CITY OF PORTLAND, MAINE
SITE PLAN REVIEW (ADDENDUM)
CONDITIONS OF APPROVAL

APPLICANT: Pine of Portland

SITE ADDRESS/LOCATION: #36 Liberty way lot 9

DATE: 3/16/00

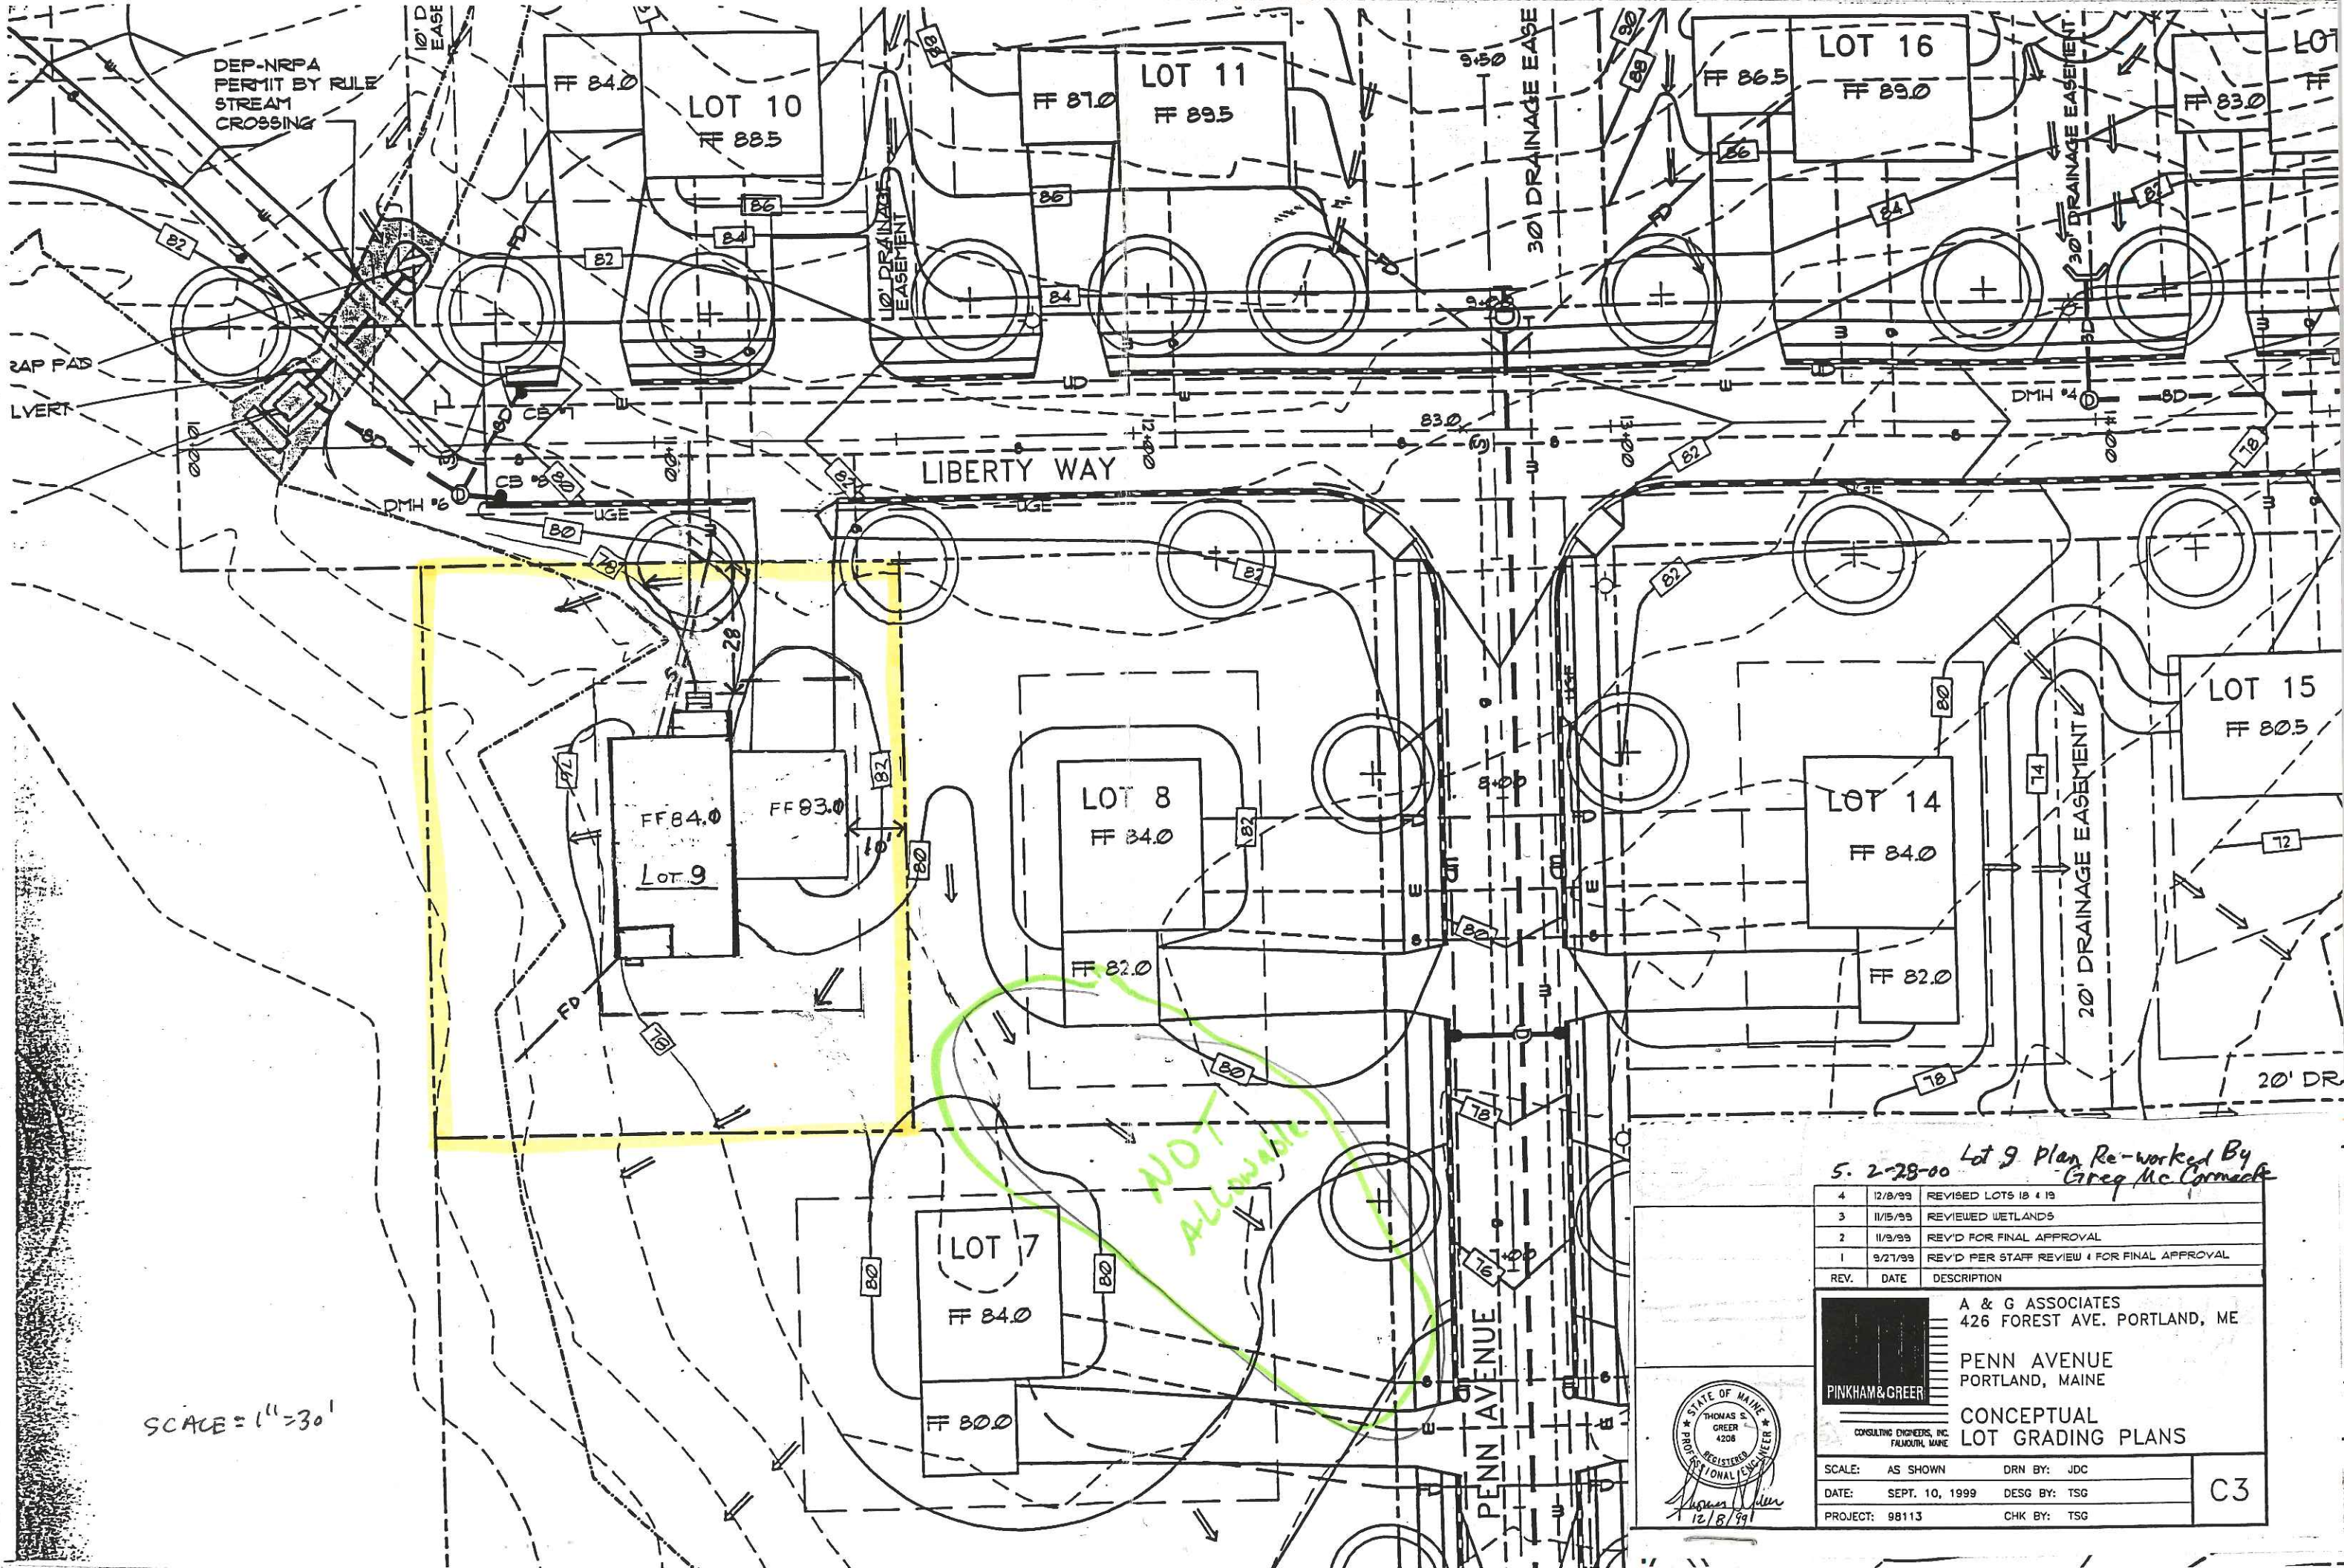
- Plan shall either be restamped by the Professional Engineer or the stamp removed
- Re direct drainage flow path between lots B & 9

to pass behind lot 7 and not across the front yard of lot 7

- Identify Any bulkhead location or daylight Basement entrance on plan.
- erosion control measures including silt fence shall be shown on plan
- An outlet invert shall be shown for the foundation drain. Will the FD be connected to a sump pump? This must be identified.
- The Applicant shall provide invert data for the sanitary sewer service. The sewer shall be insulated where there is less than 4' of cover.
- Water service shall have 5' cover minimum

• The driveway treatment shall be identified as asphalt, gravel or other
